RE: **Copper Pointe
Grading and Drainage Plan
Engineer's Stamp Date 11-13-15 (File: K21D009H3)**

COPPER POINTE
GRADING AND DRAINAGE

**Re: Copper Pointe
Grading and Drainage Plan
Engineers stamp date 11-13-15 (File: K21D009H3)**

BERM-TRENCH-PARKING LOT CROSS SECTION DETAIL

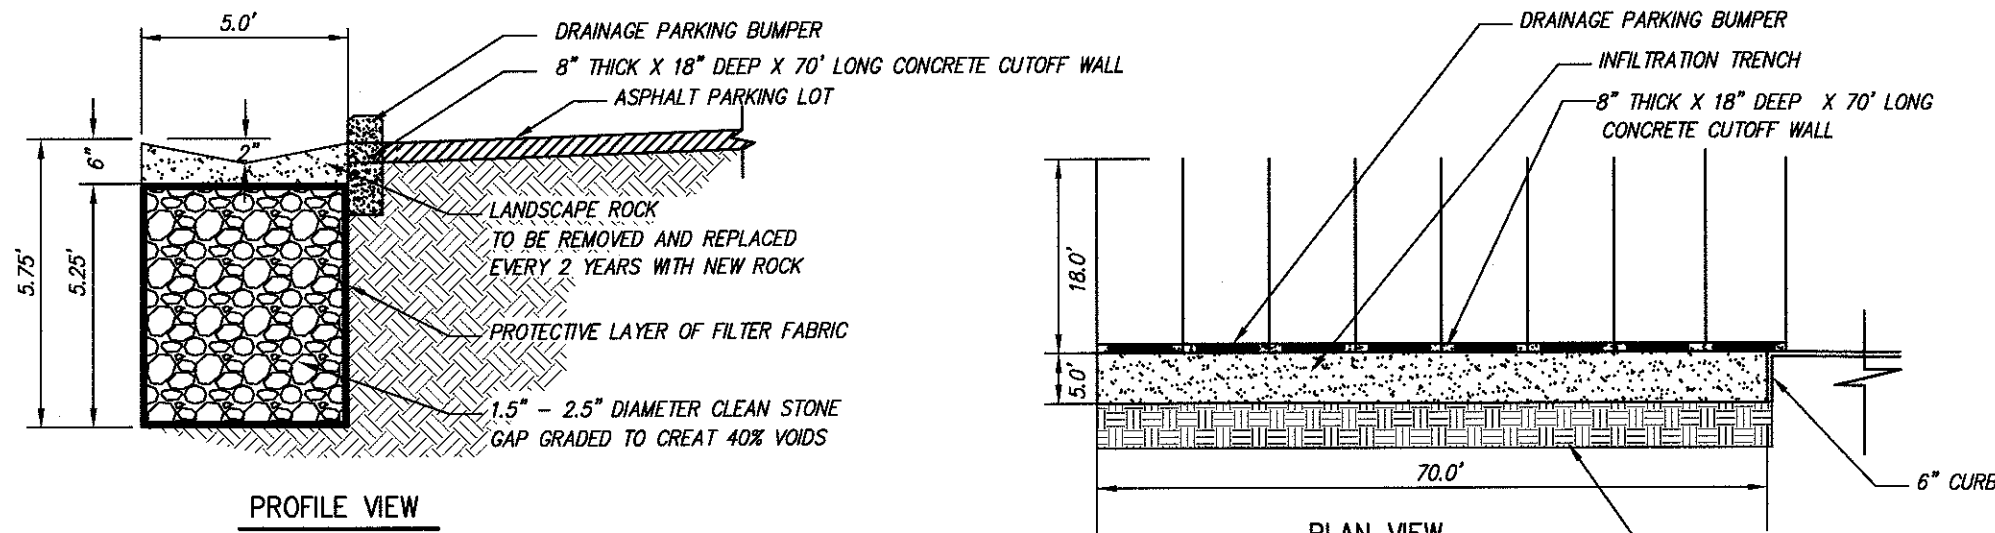
1. **"...The retaining wall footing interferes with the trench..."** The plan has been revised to reflect the replacement of the retaining wall with an earth berm. Also, a cutoff wall has been added to help prevent possible saturation of the pavement section.
